Access Compliance Report

Public Rights-of-Way (Curb Ramps)

Intersection ID: 43848	Main Street: COZEN_WY	Cross Street: ROTHMAN_LN	Location: SW
ADA ID: 342AC577B99B	Ramp Type: PerpDiag	Initial Pass/Fail: Fail	Overall Compliance: No
		Severity Score: 12.5

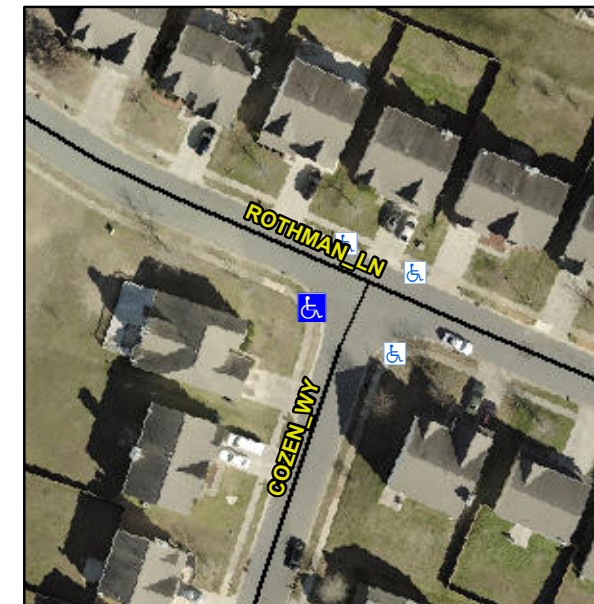
Not Found, R304.5.3

Compliance	Description	Data	Compliance	Description	Data
N/A	Ramp Length (in)	48.5	Yes	Ramp Slope (%)	6.2
Yes	Ramp Width (in)	82.0	No	Ramp XSlope (%)	6.2
N/A	Flare Type LT	N/A	N/A	Flare Type RT	N/A
N/A	Flare Slope LT (%)	N/A	N/A	Flare Slope RT (%)	N/A
N/A	Flare Traversable LT?	N/A	N/A	Flare Traversable RT?	N/A
N/A	Landing Length (in)	N/A	N/A	DWS Provided?	N/A
N/A	Landing Width (in)	N/A	N/A	DWS Contrast?	N/A
N/A	Landing Slope (%)	N/A	N/A	DWS Length (in)	N/A
N/A	Landing X Slope (%)	N/A	N/A	DWS Full Width?	N/A
N/A	Landing Curb? (Y/N)	N/A	N/A	DWS Offset (in)	N/A
N/A	Shared Landing?	N/A			
N/A	Gutter Ponding?	N/A	N/A	Gutter Slope (%)	N/A
N/A	Gutter Lip Ht (in)	N/A	N/A	Gutter X Slope (%)	N/A
N/A	Painted X Walk1?	No	N/A	Painted X Walk2?	No
	X Walk 1 Direction	To SE		X Walk 2 Direction	To NE
N/A	X Walk 1 Width (in)	N/A	N/A	X Walk 2 Width (in)	N/A
	X Walk 1 Slope (%)	7.5		X Walk 2 Slope (%)	3.6
	X Walk 1 X Slope (%)	0.1		X Walk 2 X Slope (%)	6.3

Remove & Replace Curb Ramp With Two New Directional Ramps or Equivalent.
